2190140

**RE: Response to Request for Information, Bays 1-4a of the Locomotive Workshop, South Eveleigh (SSD 8517, MOD 7)**

**Figure 3** Public domain concept plan for Innovation Plaza north, illustrating the proposed additional planters

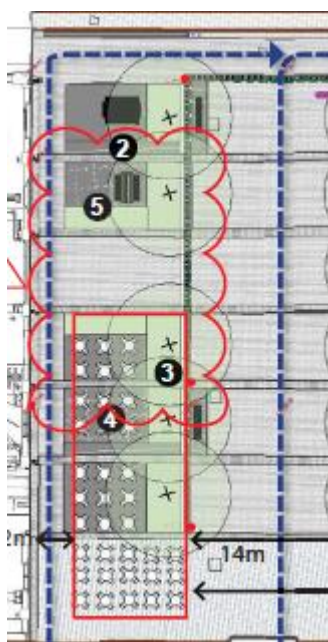
Update the public domain plan SSDA-09-REV4 and the relevant architectural plans listed above to show details of a barrier between the seating area and the southern edge of the loading dock access. This should be either retention of the approved raised landscape planter or an alternative treatment to provide physical separation for the safety and amenity of patrons of this space.

The updated public domain plans are included at **Attachment B**. They illustrate the provision of raised planters (identified by the number '5') in **Figure 3** below to provide separation between both north and south of the loading dock driveway.
